May 7, 2025

Mr. David Nguyen
Los Angeles County Public Works
900 S. Fremont Avenue
Alhambra, CA 91803
dnguyen@pw.lacounty.gov

Re: Chiquita Canyon Landfill – CUP Condition No. 69 Report

Figure 3. Temperature Spike at TMP-10 as Measured at 30 Feet from July 26 to September 12, 2024.

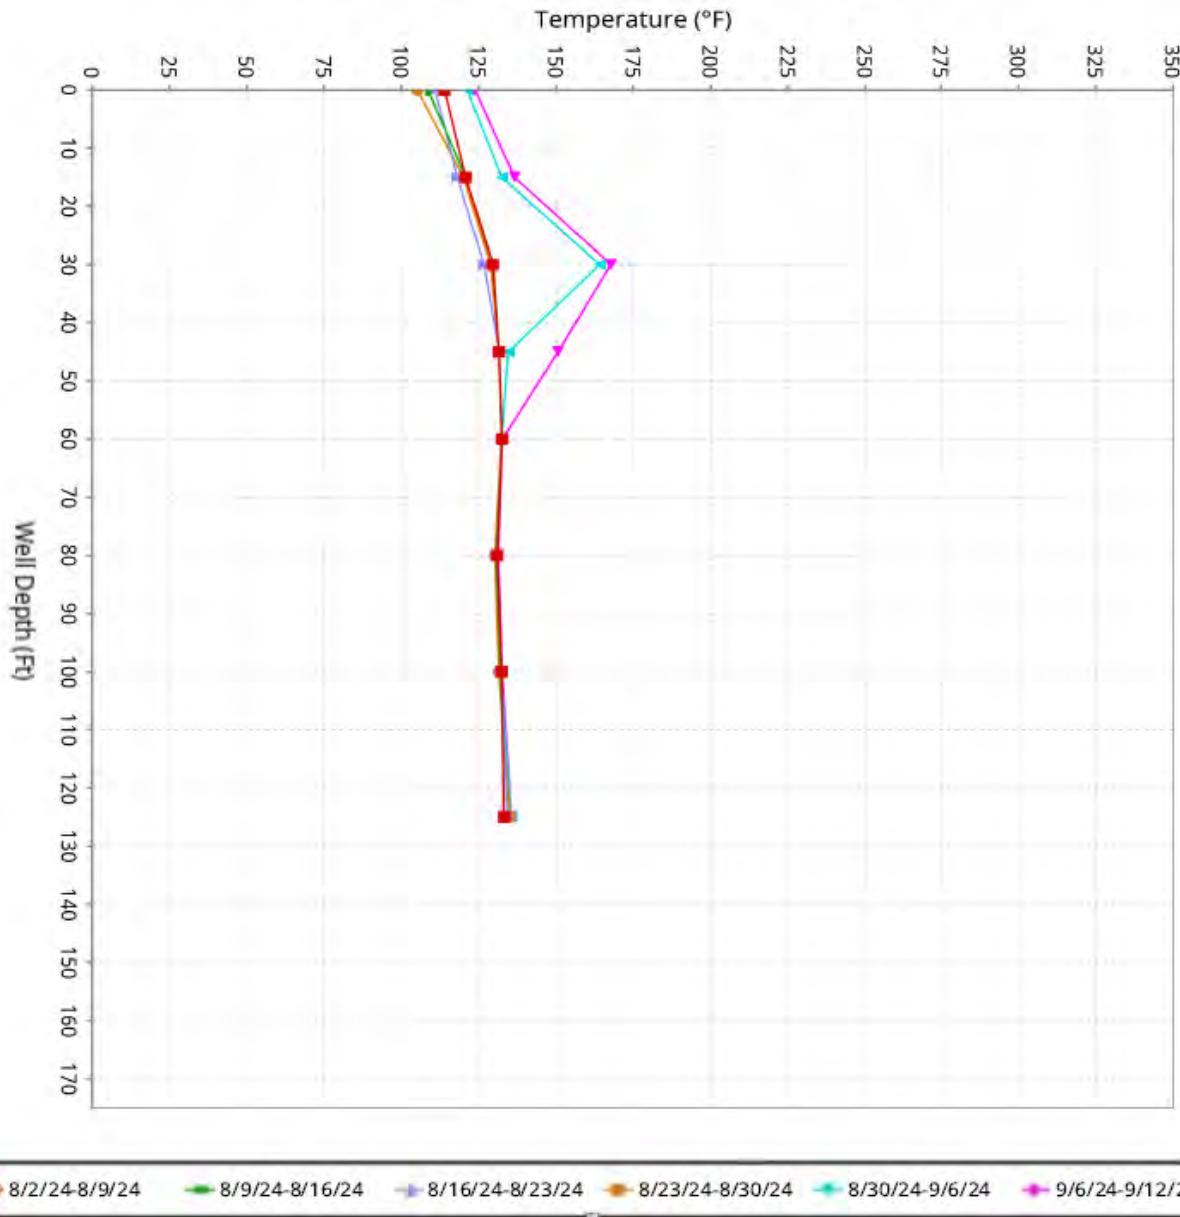
The proposed additional temperature monitoring probes (TMPs) listed in Appendix D of the Plan, including the "Sentinel" TMPs and Primary & Secondary Engagement Lines, are accepted. Due to the recent temperature spike at TMP-10, one TMP must be added at the location shown in Figure 6 in the CalRecycle Letter. The installation of these additional TMPs is required, with

- TMP-10 increased by 19.8°F within 48 hours from August 30 to September 5, 2024, and 41.6°F in 14 days from 126.1°F to 167.7°F from August 25 to September 8, 2024.
- TMP-13, TMP-15, and TMP-17 also show temperature spikes of 20°F to 25°F during the week of August 16 to August 22, 2024. The most significant temperature spike was from TMP-15, where the temperature rose 33.4°F in one day from September 5 to September 6, 2024, at the 30-foot thermocouple. Figures 2 and 3 show examples of the shallow temperature spikes in TMP-13 and TMP-10, respectively.
- The CCL-identified reaction zone from the depths of 70 feet to approximately 140 feet has remained consistent since July 26, 2024.

Figure 4. CCL's Temperature Probe Installation Project, Dated July 2024.

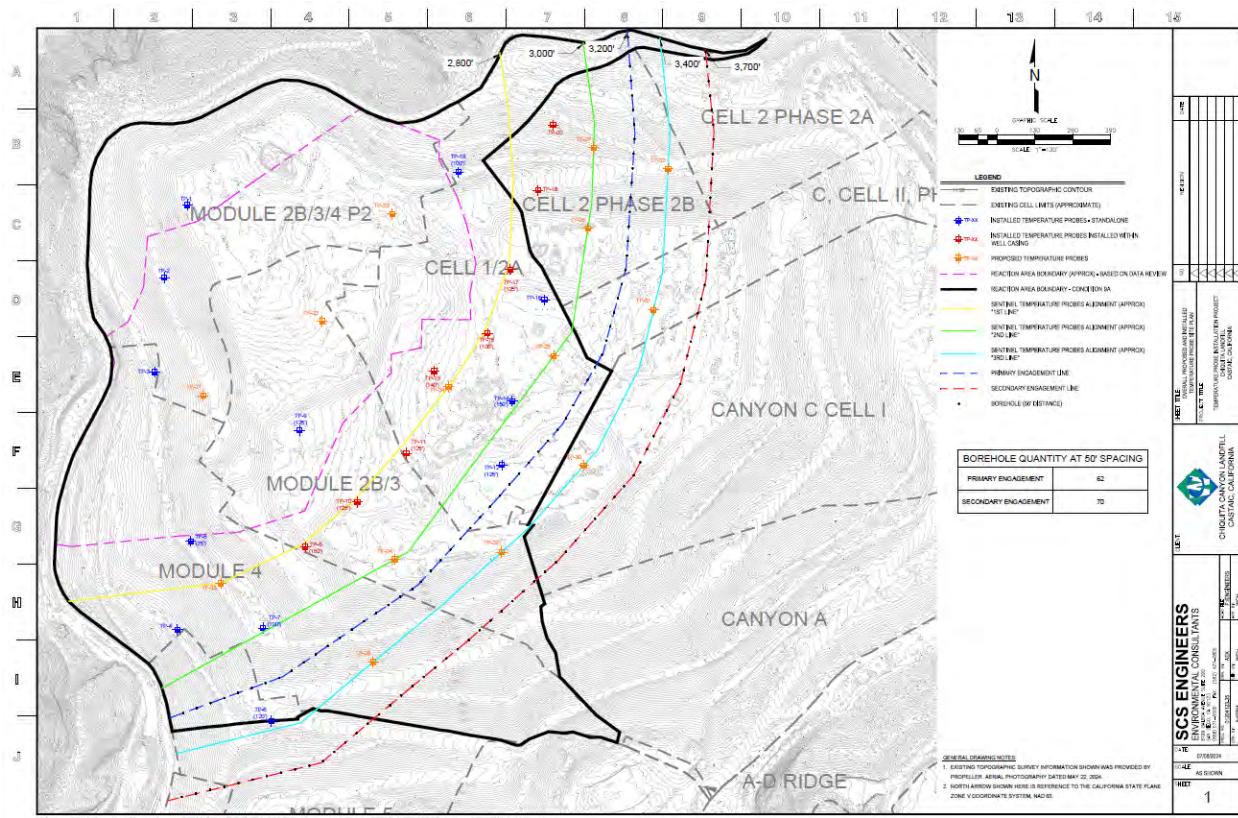
The CCL proposes to install the reaction break/barrier at the primary and/or secondary engagement lines, as shown in Figure 4, only if all the Threshold Criteria Limits shown in Exhibit 1 are exceeded at the corresponding Sentinel Monitoring Network (i.e., TMPs and associated vertical LFG extraction wells). The criteria for implementing containment strategies will be the same as determining whether the reaction is expanding with several verifications to ensure the decision to install a barrier is valid. Temperature will be the primary standard for installing a barrier, with LFG data being the secondary standard.

Figure 5. Vertical Shaft Barrier.

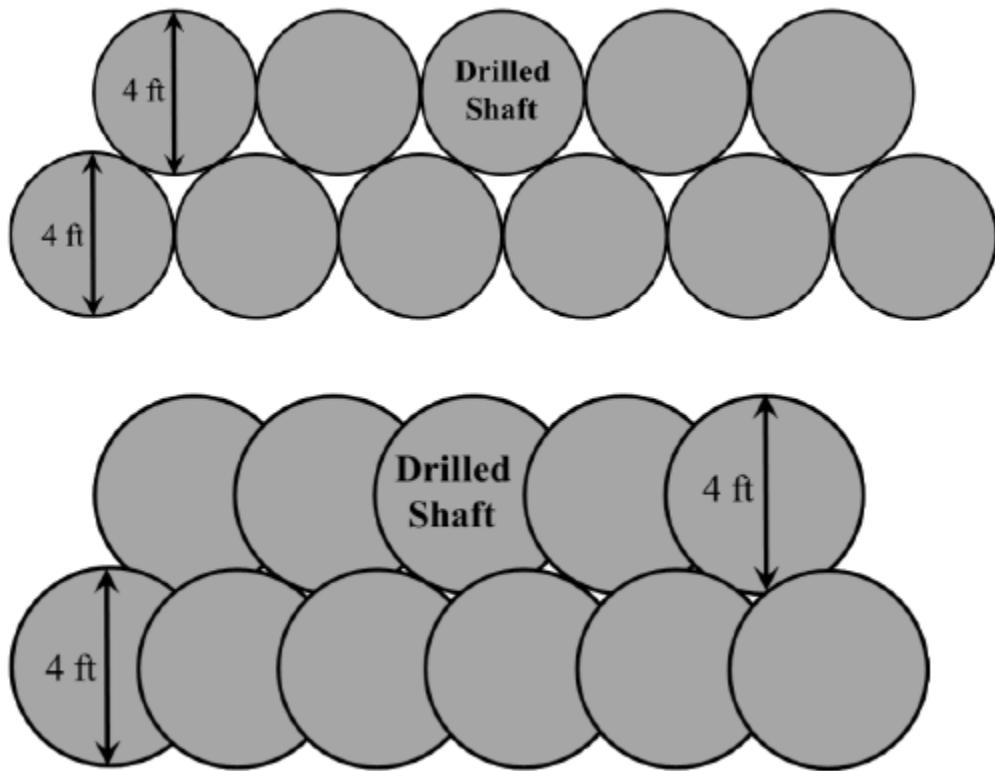
For deeper reactions, the barrier must be constructed using borehole drilling combined with flowable fill injection. If this method proves ineffective, a vertical shaft barrier should be installed using a bucket auger drill rig with a 3 to 4-foot diameter auger, drilled to a minimum depth of 50 feet or leachate liquid level, and backfilled with a cement-bentonite or soil-bentonite mixture to form a continuous barrier. See Figure 5 in the CalRecycle Letter.

Figure 1. Temperature profiles over six weeks from 1/9/2025 to 2/19/2025 from SCS report dated February 20, 2025.

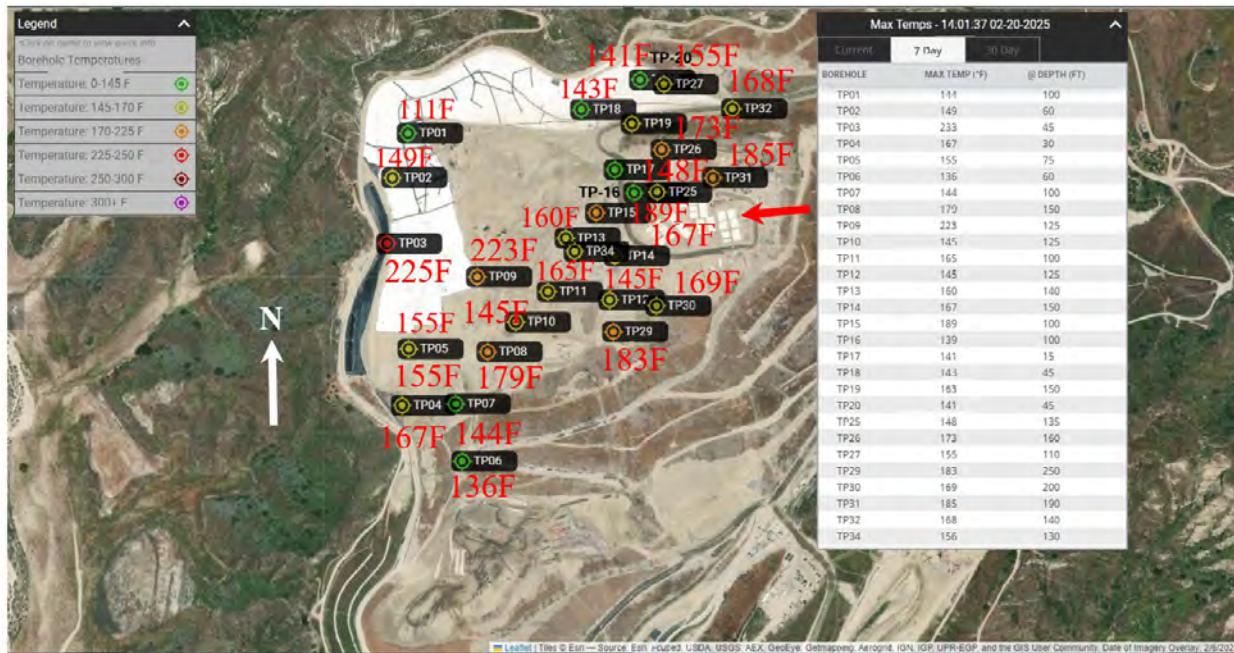
SCS presents Waste Borehole Maximum Temperature Profiles Over 6 Weeks from January 9, 2025 to February 19, 2025.⁶ An aerial image of CCL with a table of maximum temperatures is included in the subject SCS Report and reproduced in **Figure 1**. I have placed the maximum waste temperature from the table in **Figure 1** adjacent to some of the gas extraction wells to facilitate understanding the extent of the SET Event, especially on the east side of CCL. **Figure 1** shows waste temperatures of 183°F and 185°F at the eastern side of the top deck of the CCL. This means the SET Event has migrated from the western slope (TP03) to the eastern side of the CCL (TP31). Expansion of the SET Event has the following implications:

- Elevated temperatures (185°F to 189°F) surround the leachate tank farm (see red arrow in **Figure 1**). This area is going to undergo significant settlement, if it has not already started to do so, due to thermal breakdown of the buried waste. This settlement will cause differential movement of the leachate tanks, which could result in a leachate release. As a result, I recommend the leachate tank farm be moved off the top deck and to a site off the CCL and on native soil because the SET Event continues to expand.

end to just south of TP06 shown in **Figure 1**. In other words, the exposed geomembrane cover would cover about 183 acres and leave only about 13 acres at the southern end of the CCL uncovered for current disposal operations.

Figure 2. Extent of elevated temperatures from March 27, 2024 to February 26, 2025.

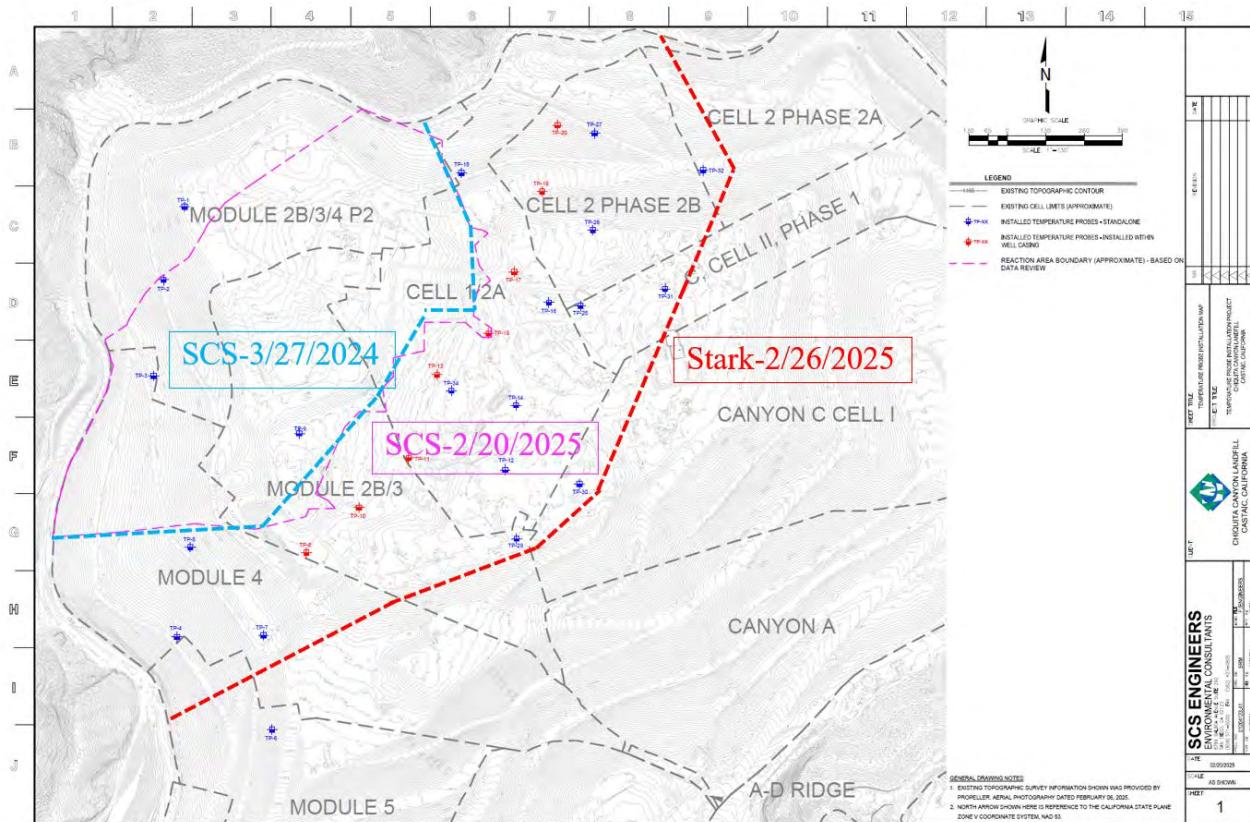
Figure 2 presents Sheet #1 from the SCS Report that presents the Waste Borehole Maximum Temperature Profiles Over 6 Weeks from January 9, 2025 to February 19, 2025.⁷ The dashed pink line represents the extent of the SET Event as determined by SCS on February 20, 2025. This extent is slightly larger than the dashed blue line, which represents the extent of the SET Event on March 27, 2024 as reported by SCS in the initial Soil Reaction Break/Barrier Plan.⁸ **Figure 2** also presents my extent of the SET Event as of February 26, 2025 (see dashed red line) based on the Waste Borehole Maximum Temperature Profiles Over 6 Weeks from January 9, 2025 to February 19, 2025.⁹ **Figure 2** shows the western slope and entire top deck of the CCL is now part of the

SET Event, which is a significant increase over the extent reported by SCS on March 27, 2024¹⁰ and February 20, 2025.¹¹ Based on **Figure 2**, SCS believes the SET Event only covers about 28 acres as of February 20, 2025 whereas my extent of the SET Event covers about 90 acres.

Figure 7. Extent of elevated temperatures on February 26, 2025 and location of a possible vertical barrier to isolate southernmost 13 acres.

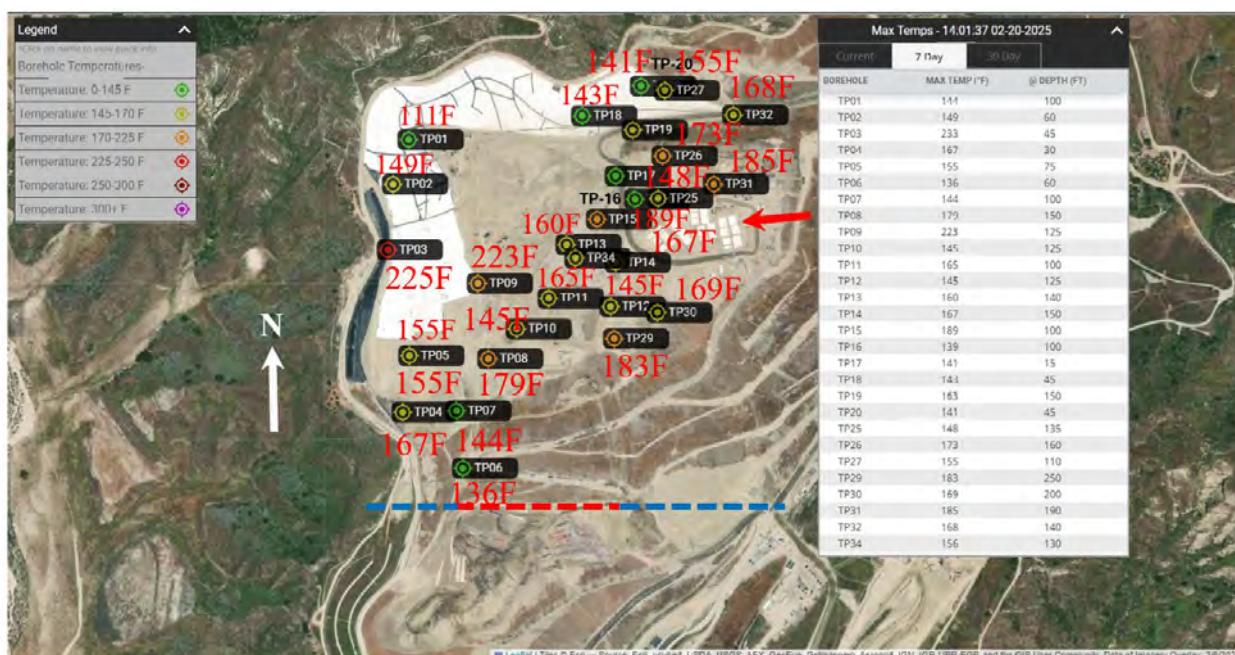
Given the west side and top deck of the CCL are experiencing elevated temperature, I unfortunately think the only remedial option is to cover the entire landfill north of TP06 or north of the red and blue dashed line shown in **Figure 7**. The elevated temperatures have not manifested themselves on the eastern slope yet, but I anticipate leachate outbreaks could start occurring because elevated temperatures (183°F and 185°F as shown in **Figure 1**) are present at the crest of the eastern slope.

exposed EVOH geomembrane over the area to the north of the red and blue dashed line shown in **Figure 7**.

This section discusses installing a thermal barrier south of TP06 (see dashed red and blue line in **Figure 7**). A thermal barrier is recommended along the dashed red and blue line in **Figure 7** for at least the following reasons:

- CCL is using the approximately 13 acres south of the dashed red and blue line in **Figure 7** for disposal operations so elevated temperatures should be prevented from reaching this area, so the landfill continues to have an area to dispose of on-site wastes.
- Ensure continued ingress and egress from the CCL.
- Reduce the amount of waste that can be consumed by the SET Event and thus reduce the duration of odors and emissions to the surrounding communities.
- Maintain stability of the southern sideslope.

The red dashed line in **Figure 7** roughly delineates the location of a thermal barrier already constructed by CCL. The extent and depth of the thermal barrier are not known, so I request this information be provided by CCL. The blue dashed lines in **Figure 7** indicate the existing thermal barrier should be extended east and west so the SET Event cannot go around or under the existing thermal barrier.

If the existing thermal barrier does not extend to near below the leachate level, vertical elements can be used to create a vertical thermal barrier to prevent the SET Event from impacting the southernmost 13 acres of the CCL. The vertical elements involve excavating a vertical shaft using a three or four-foot bucket auger drill rig, which is being used to install gas extraction wells at CCL. These vertical elements would be constructed along the dashed red and blue lines in **Figure 7**. After excavating the shaft, it could be backfilled with a soil-bentonite or soil-cement mix. The shafts would be tangent, i.e., touching, or overlapped (see **Figure 7**) to create a continuous barrier across the toe of the southern sideslope to prevent the SET Event from consuming the southernmost 13 acres. If heat transfer calculations require a wider thermal barrier, a second row of vertical elements could be constructed north or south of the initial row (see **Figure 7**). The secondary row would be tangent to the initial row and be centered at each intersection of the initial row as shown below (see **Figure 7**).

5. Submit a Request For Information (RFI) regarding the current extent and depth of the thermal barrier installed near the southern end of the CCL (see red dashed line in **Figure 7**), and

Figure 2. TMP-14 Temperature Profile Demonstrating a Shallow SET Event Developing at Chiquita Canyon, April 24, 2024, to March 19, 2025. (Source: SCS Engineers TMP Data)

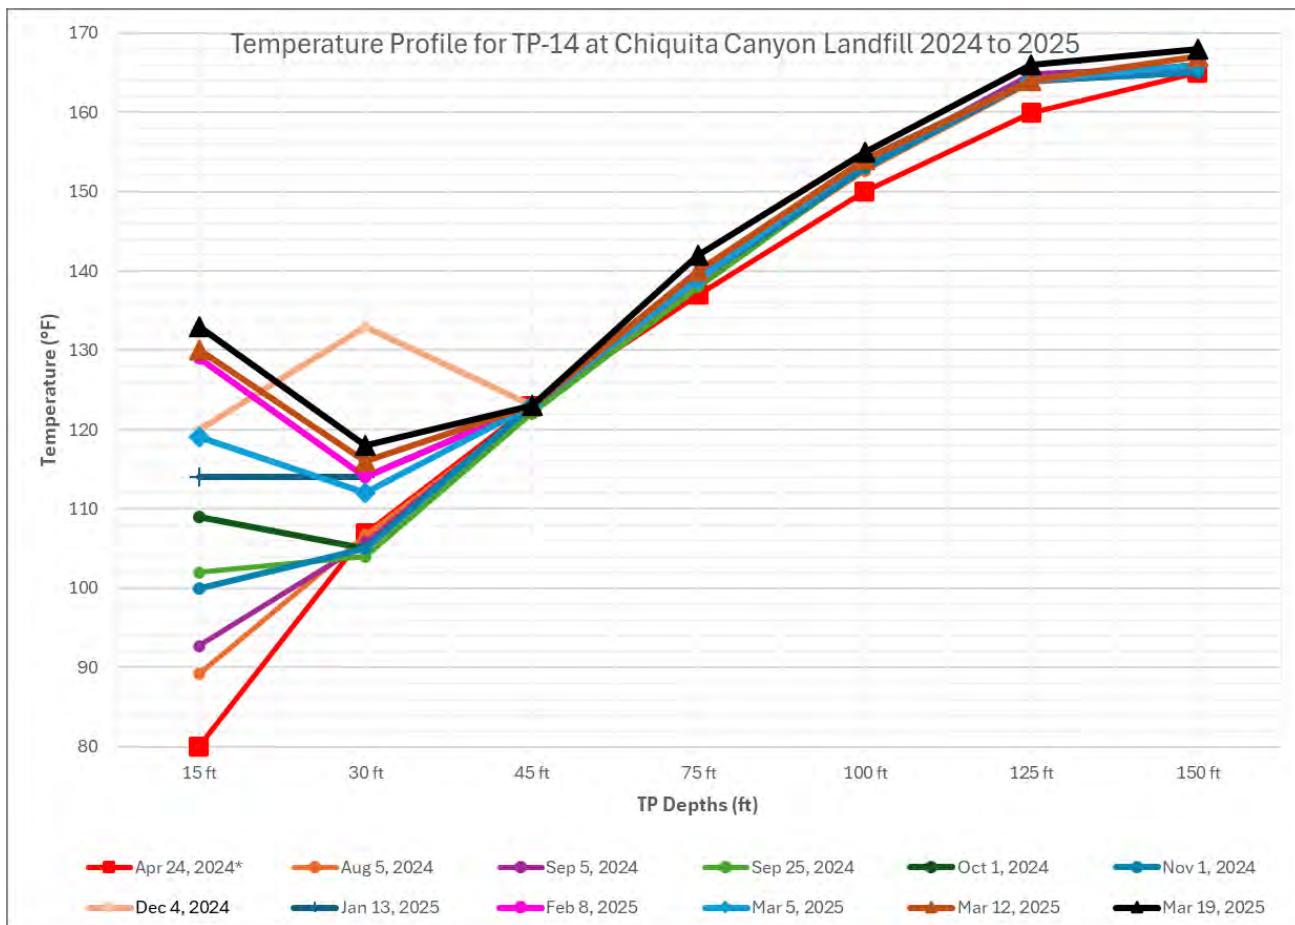
As an example of how wellhead temperatures can mask what is occurring in the waste, as shown in **Figure 2**, TMP-14 reported a temperature of 80°F (26.7 °C) on April 24, 2024, at the fifteen-foot probe. By March 19, 2025, the temperature at the 15-foot probe had increased to 133°F (56°C). This shallow temperature spike was not observed in gas well CV-1906, approximately 10 to 15 feet away, where the wellhead temperature was reported to be 68°F (20°C) on April 1, 2024, and 60°F (15.5°C) on March 19, 2025. There were also significant temperature swings in the wellhead temperature data for gas well CV-1906, where the temperature rose from 95°F (35°C) to 121°F (49°C) and then dropped to 73°F (22.7°C) within a month. However, all the wellhead temperatures are below the regulatory threshold and do not require further analysis. Data from TMP-14 indicated that on March 19, 2025, the temperature reached 133°F (56°C) and exceeded the 131°F (55 °C) threshold. CV-1906 is also experiencing a significant oxygen overdraw at this location. The percent oxygen has varied from 10.9 percent on March 4, 2024, to 18.7 percent on March 6, 2025. The average oxygen for the past year at this well is 8.4 percent. Continued high oxygen levels above 2 percent and temperature spikes will lead to a SET Event. This TMP and gas well are approximately 450 feet away from the CCL-defined reaction boundary and CalRecycle staff do not believe the shallow temperature increases are connected to the main reaction area. CalRecycle believes that the temperatures of 166 to 168°F (74.4 to 75.5°C) at the deeper probe (i.e., 125 to 150 ft) are connected. However, this data demonstrates that the operation of the GCCS must not sacrifice LFG operational objectives/standard operating procedures (i.e., limiting oxygen to 2 percent¹⁵) to control emissions and risk developing of new SET Events. **Table 2** and **Table 3** provide the LFG data and temperatures for gas well CV-1906 and TMP-14.
